RECEIPT DATE: 11-30-22 **ONSITE SEWAGE DISPOSAL SYSTEM**

APPROVAL DATE: 2/16/23 **PERMIT: CONSTRUCTION**

PROPERTY ADDRESS: 1910 DAVIS BRANCH ROAD, WOODSTOCK, MD 21163

PROJECT:	MYRTUE PROPERTY LOT 31	
LOCATION:	TAX MAP: 10, GRID: 24, PARCEL: 225, ZONED: RC-DEO 1910 DAVIS BRANCH RD. WOODSTOCK, MD 21163 6TH ELECTION DISTRICT, HOWARD COUNTY, MD, TAX ID 352668	
TITLE:	ONSITE SEWAGE DISPOSAL PLAN	
HOUSE TYPE:	CUSTOM - KEYSTONE HOMES	
DATE:	OCTOBER, 2021	PROJECT NO. 2099
SCALE:	AS SHOWN	DRAWING 1 OF 2

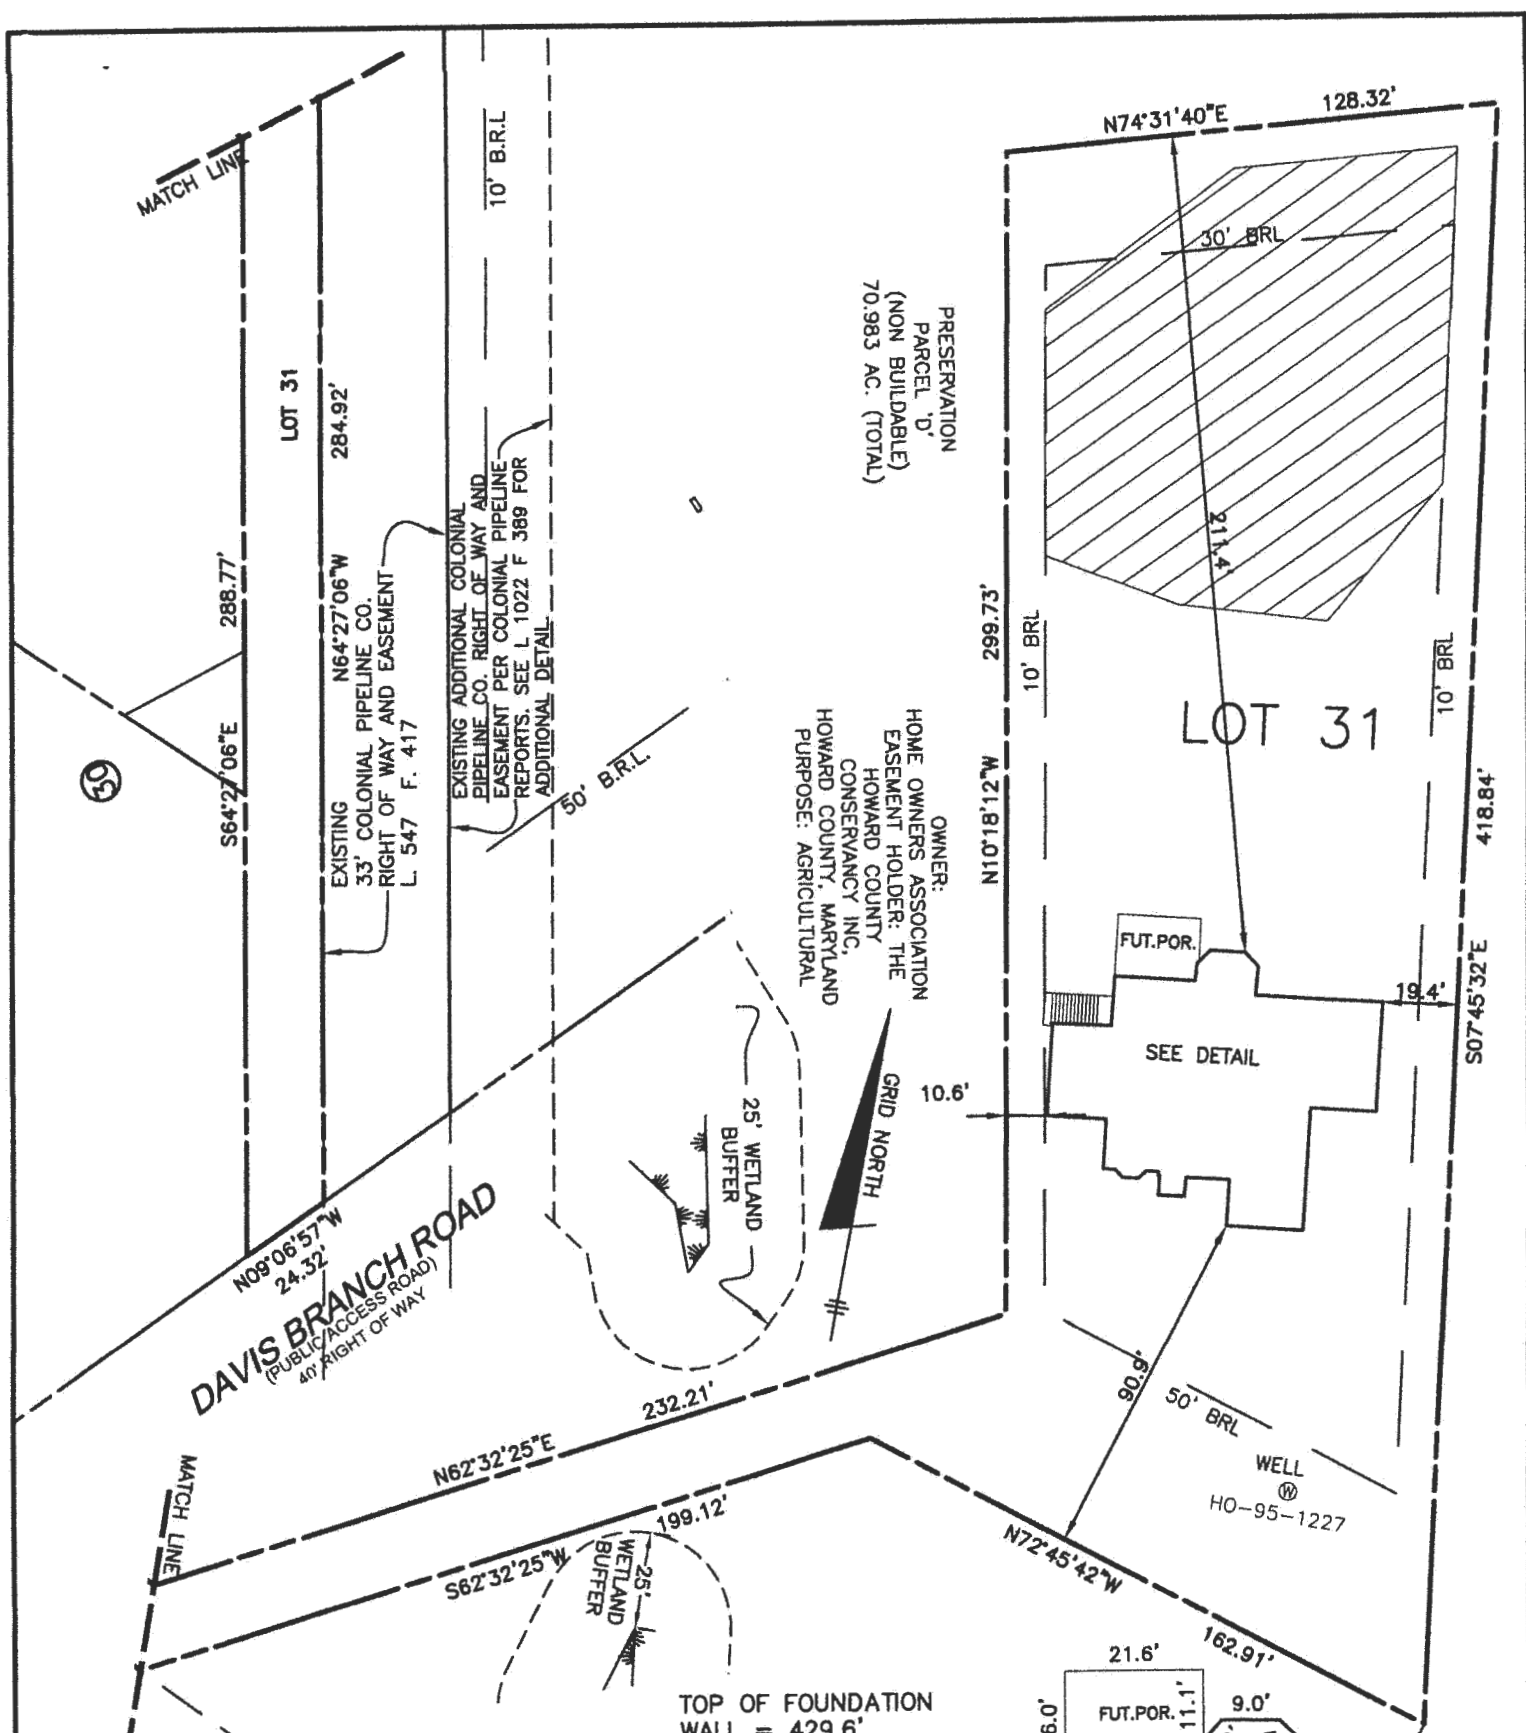
12/12/22 - No tag on well. Onsite w/ contractor for layout. Length between trench was longer than 10'. Septic tank & SDA staked. Couldn't layout trenches because distances did not match plan. T<sub>3,4</sub> called for 47' but stakes did not allow for that length. Contractor would like to reline tank & d box lot. (SP)

12/18/22 - Spoke to contractor - fill must be removed and the plan needs to be red lined for the proposal to relocate the tank. (RB) 1/18/23 - laid out 4 trenches according to plan and

2/3/23 - Farm & Home onsite for inspection, finishing last trench. T<sub>1</sub> invert at 3' per plan. T<sub>2&3</sub> invert at 2' per plan. T<sub>4</sub> invert at 2.5'. trench width 3' per plan. Very cold outside, could not level d-box, will call in for reinspection. (SP)

2/16/23 - Contractor onsite to level d-box. D-box successfully leveled. Contractor also removing fill during inspection. (SP)

**PLAN VIEW**  
1" = 50'

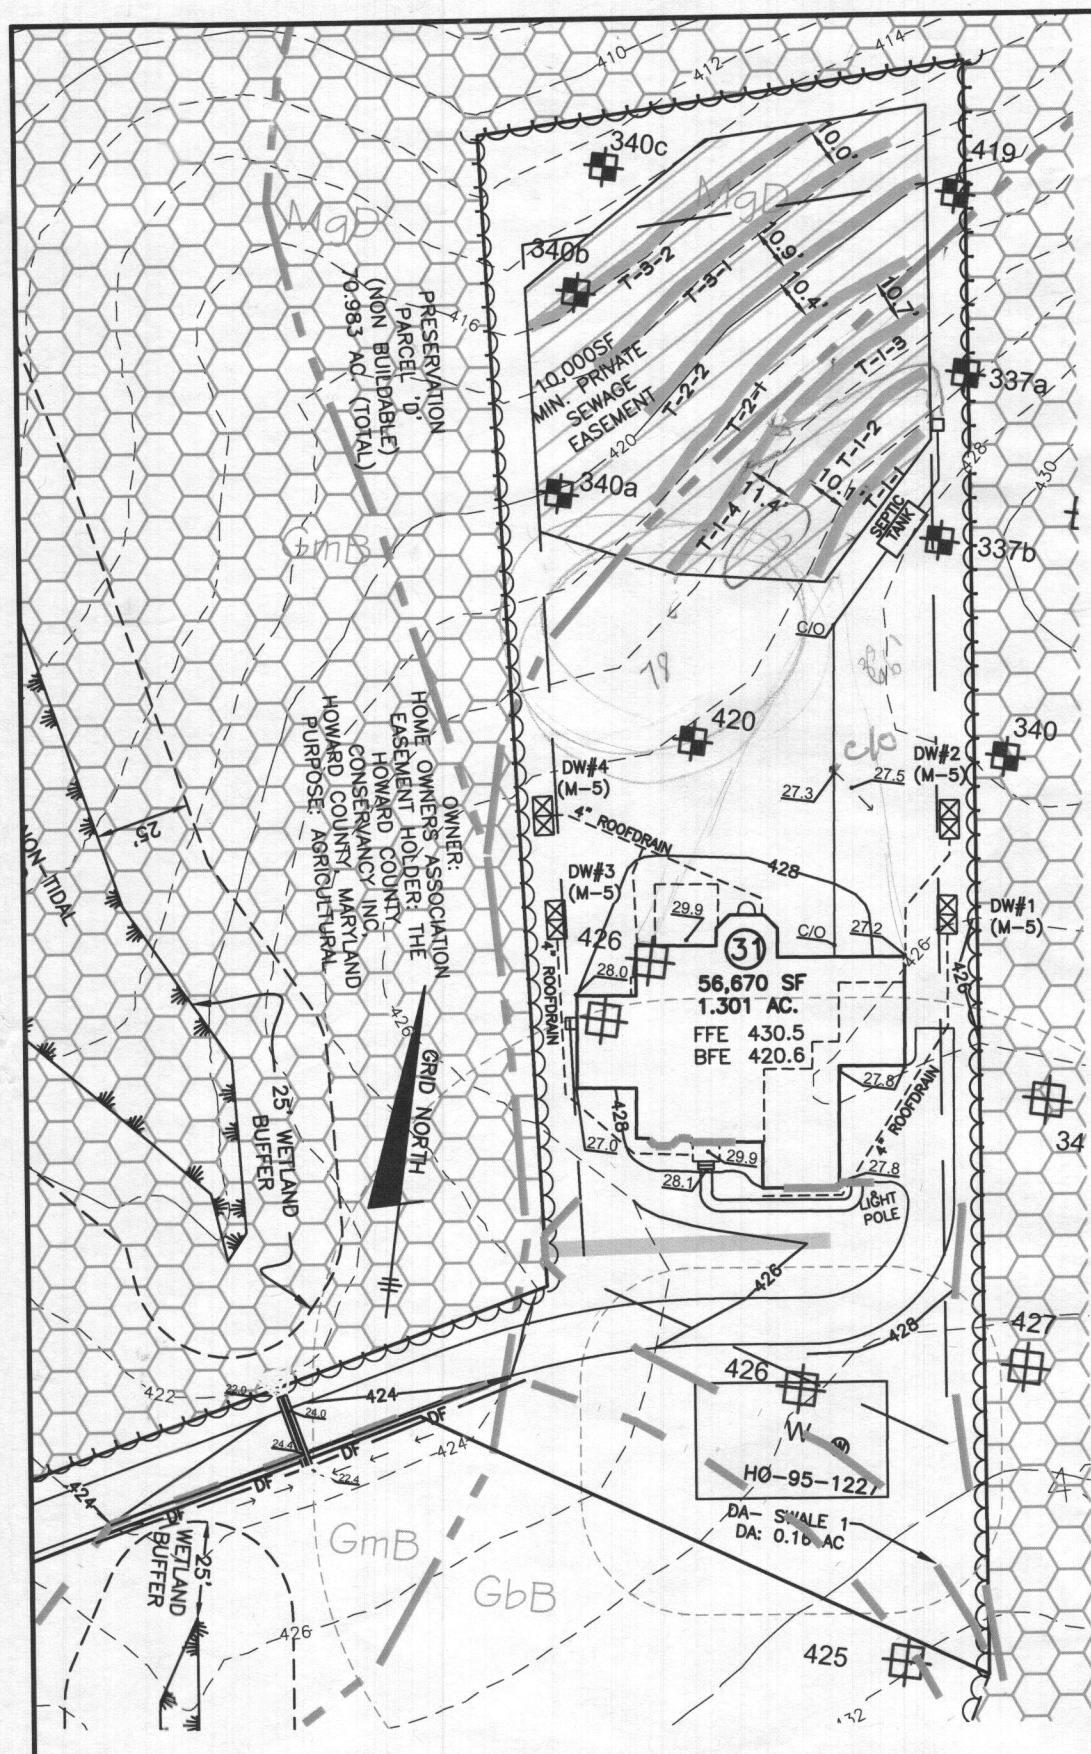
\* Revised Tank and Dist. Box Location to allow Install 12/19/22
